NORTH ANNA UNITS 1 & 2
587.8°F REACTOR COOLANT SYSTEM
STONE & WEBSTER/BOP
SAFETY EVALUATION SUMMARY

STONE & WEBSTER ENGINEERING CORPORATION
OCTOBER 1982

ENCLOSURE 3

North Anna
Technical Specifications Changes
for
Tavg of 587.8°F

FIGURE 2.1-1-1 REACTOR CORE SAFETY LIMITS FOR THREE LOOP OPERATION,

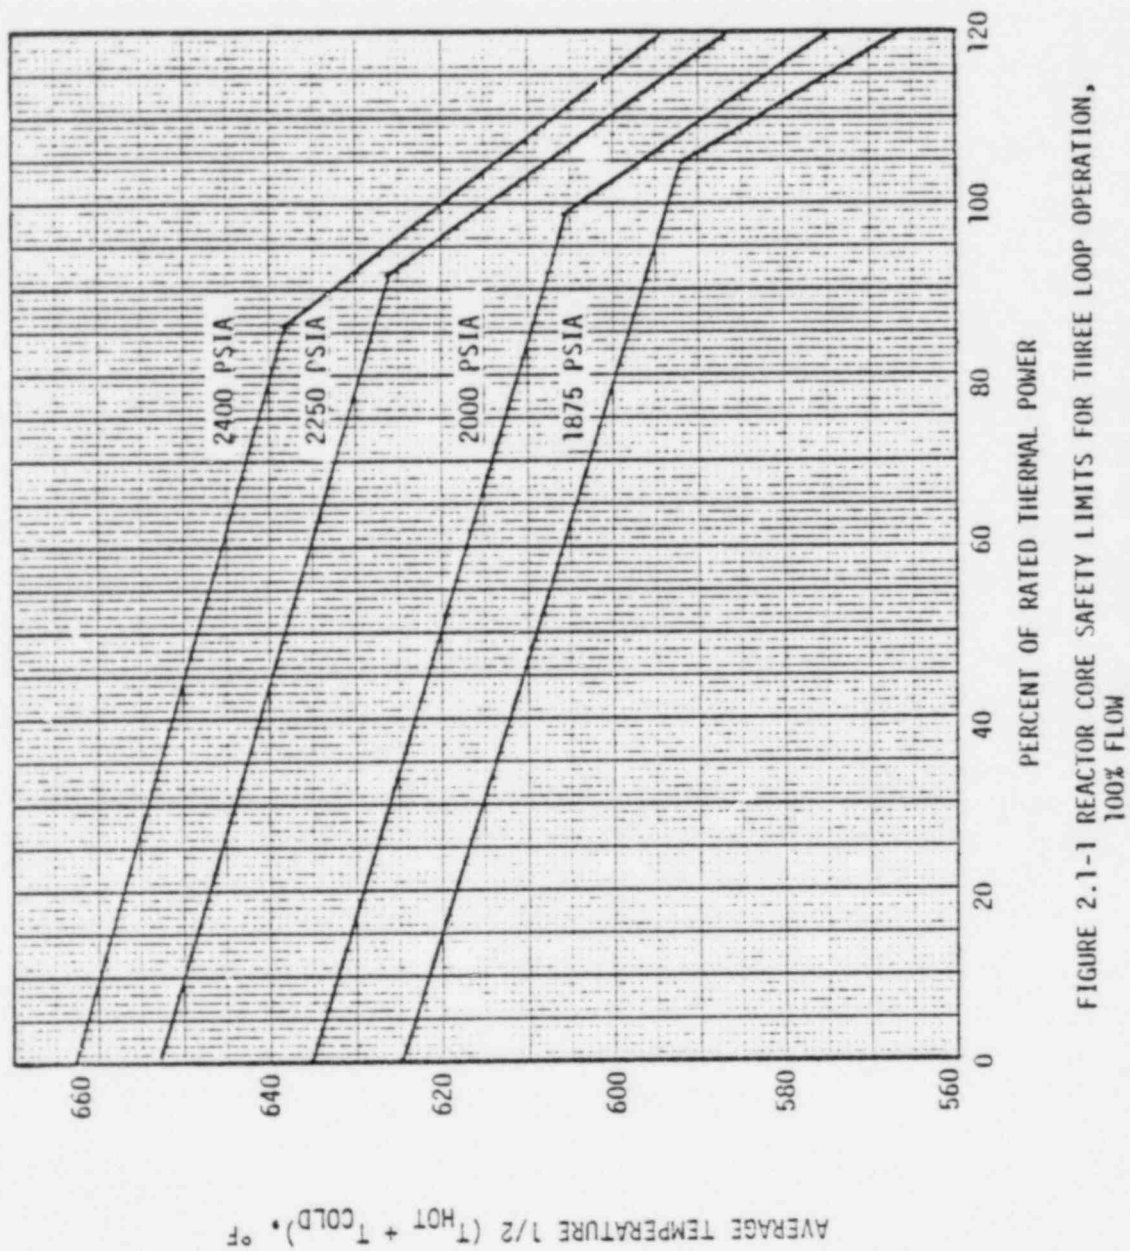
Note: Changes denoted by a double bar, ||, are identical to those in the most recent LOCA analysis NRC submittal, Vepco letter Serial No. 490, dated August 16, 1982.

Figure 3.2-2 $K(Z)$ - Normalized $F_Q(Z)$ as a Function of Core Height

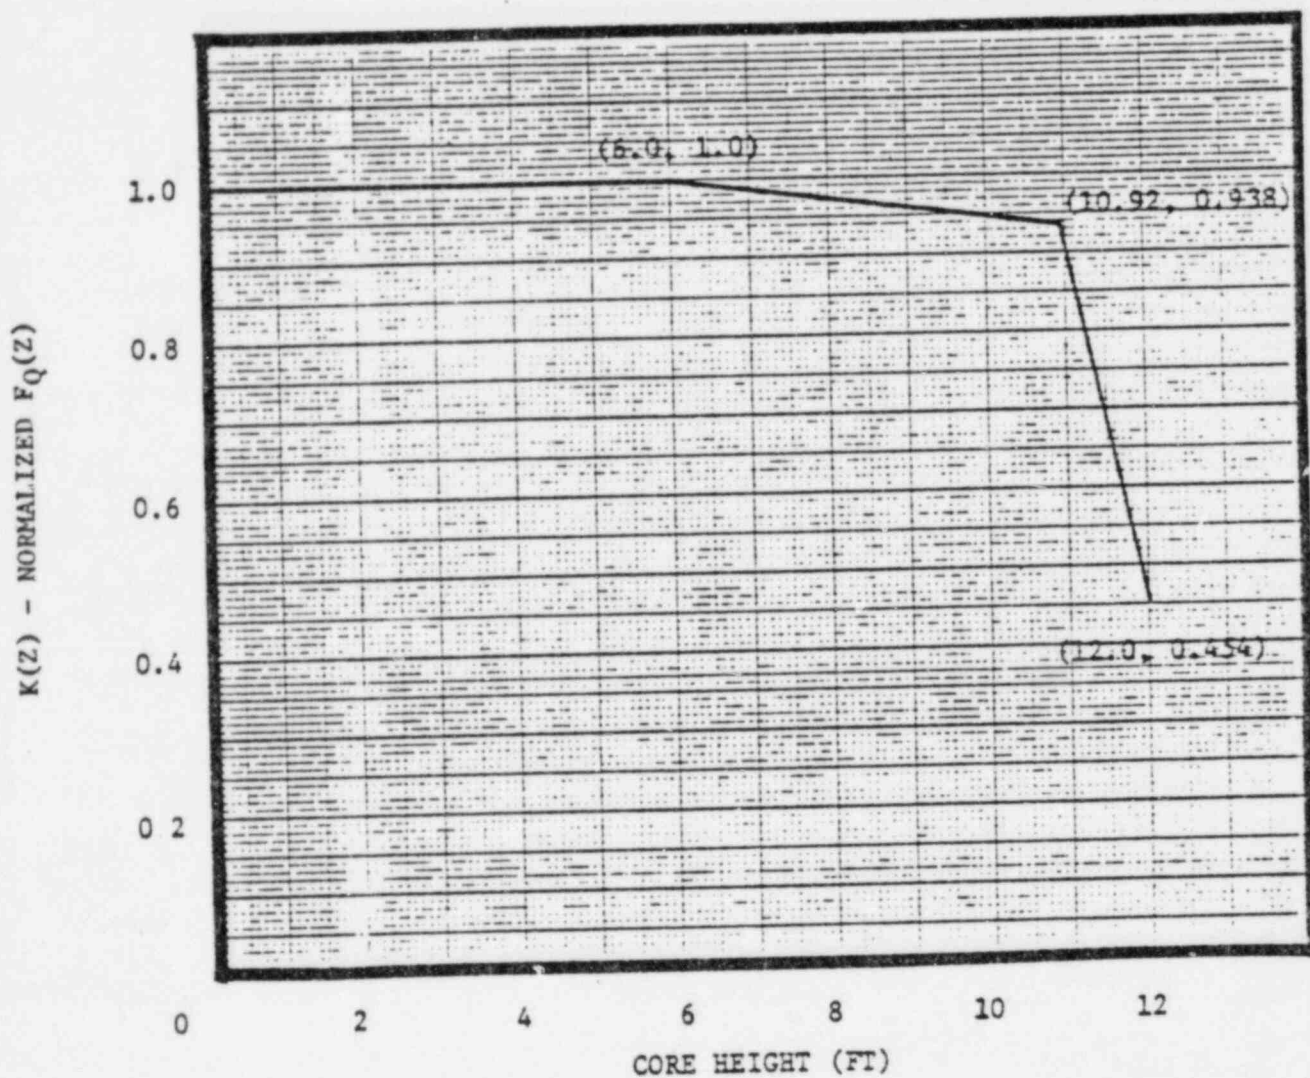
and $K(Z)$ is the function obtained from Figure 3.2-2 for a given core height location.

$$F_Q(Z) \leq \frac{[2.20]}{P} [K(Z)] \text{ for } P > 0.5$$

$$F_Q(Z) \leq [4.40] [K(Z)] \text{ for } P \leq 0.5$$

Figure 3.2-2 $K(Z) - \text{Normalized } F_Q(Z)$ as a Function of Core Height

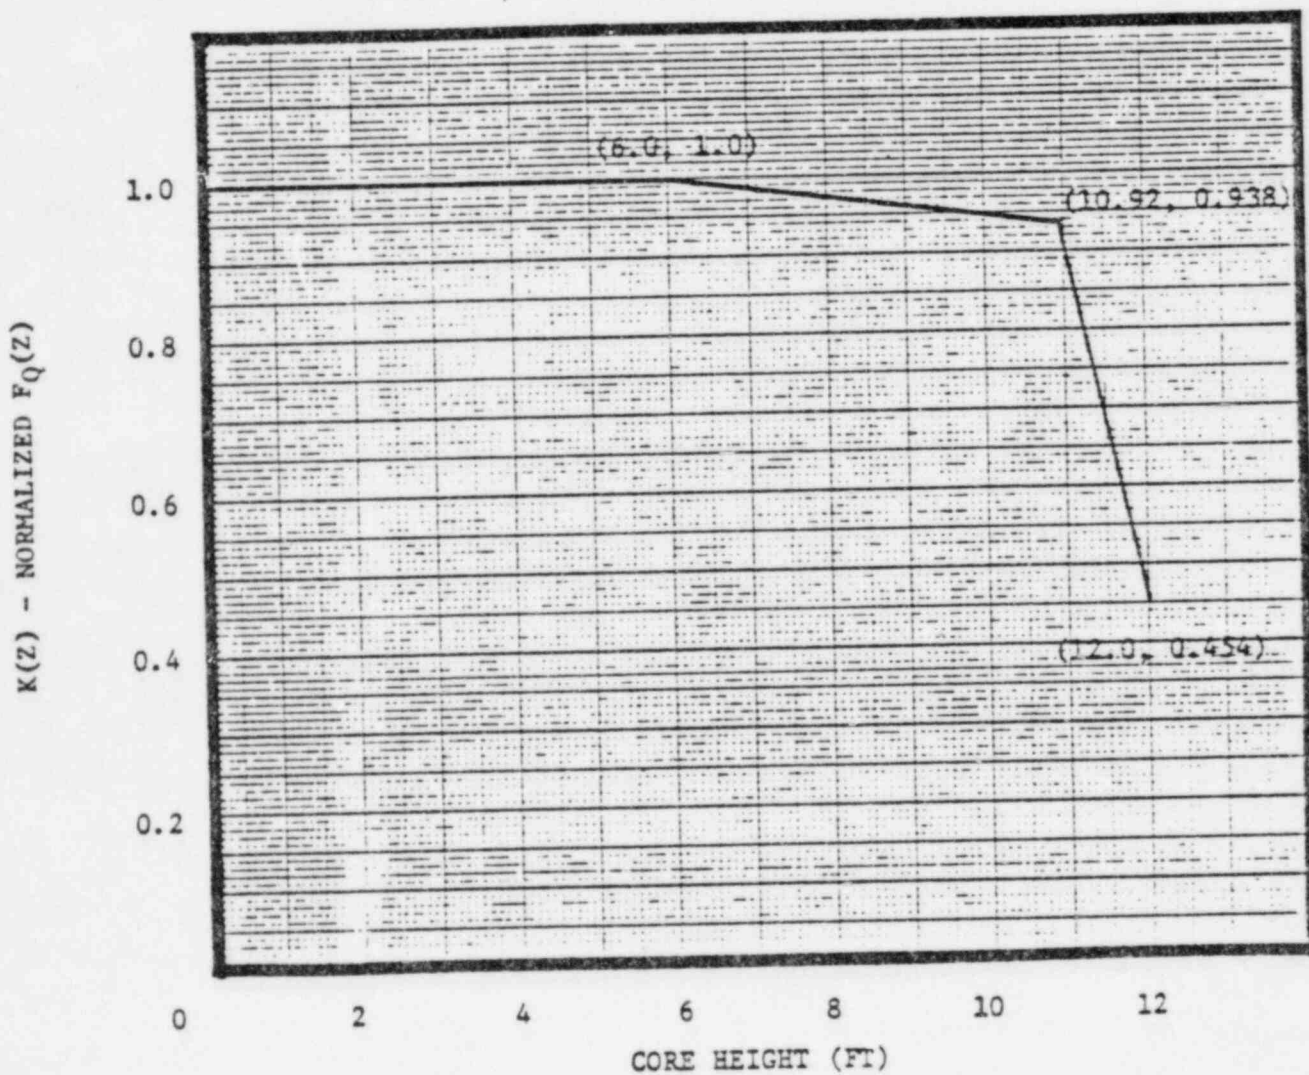
and $K(Z)$ is the function obtained from Figure 3.2-2 for a given core height location.

$$F_Q(Z) \leq \left[\frac{2.20}{P} \right] K(Z) \text{ for } P > 0.5$$

$$F_Q(Z) \leq [4.40] K(Z) \text{ for } P \leq 0.5$$
